ADDENDUM # 1

Eugene School District 4J
Willard Site Gymnasium Remodel Asbestos Abatement Project 2020
Eugene, Oregon

DATE: January 06, 2020

JOB NO: 460.191.003

Diagram A-1

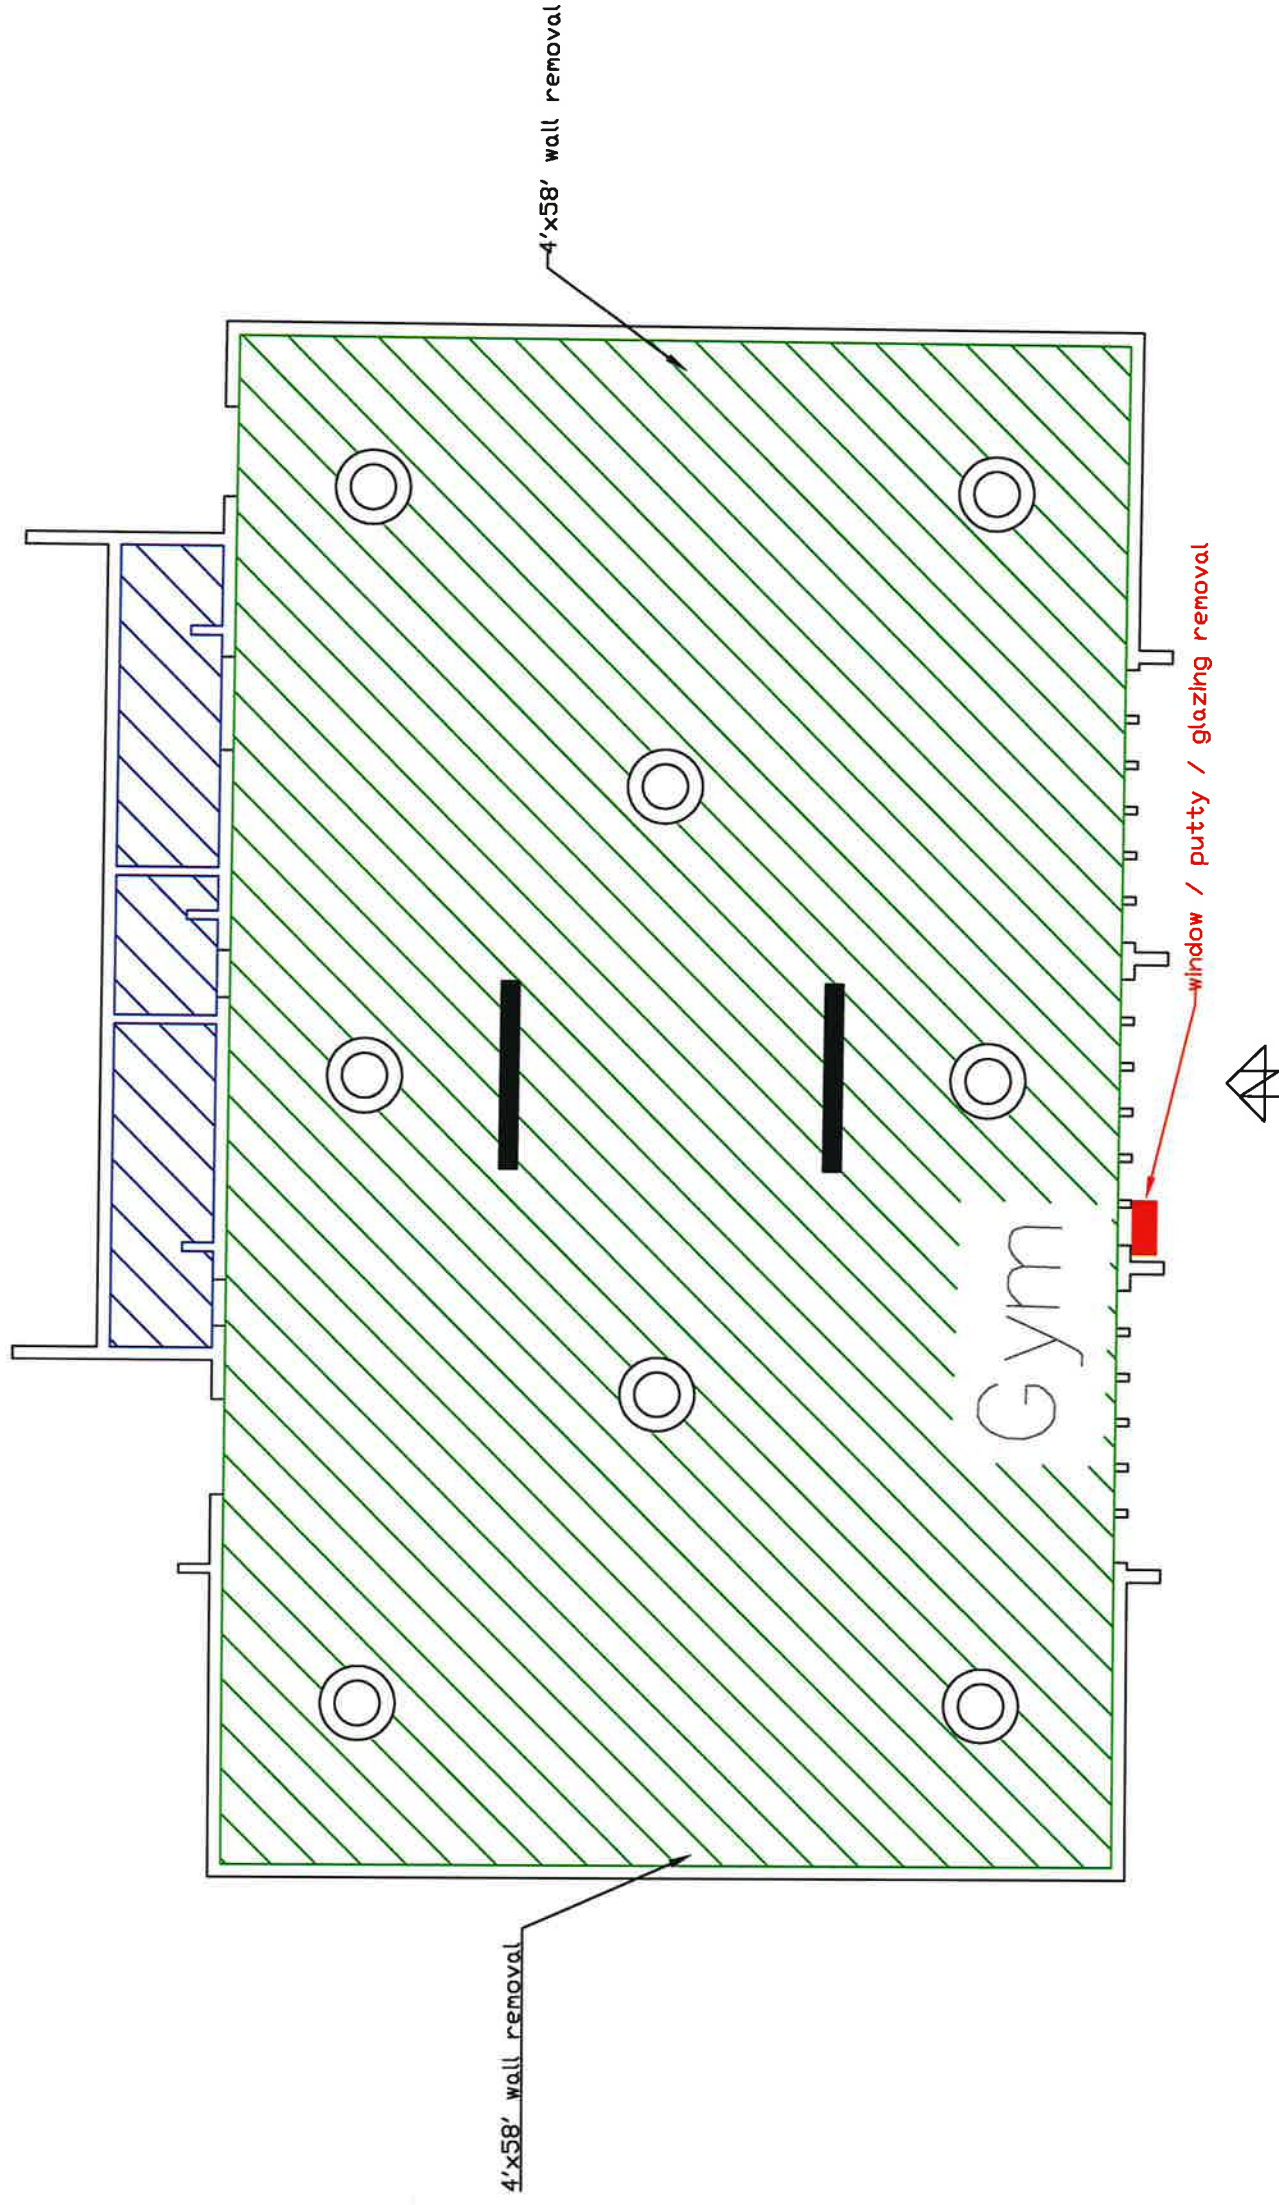
Delete 4'x58" from Drawing A-1 along the west and east walls in the Abatement Floor Plan that is provided in the Project Manual

Add 4'x58' from Drawing A-1 along the west and east walls in the Abatement Floor Plan attached to this Addendum
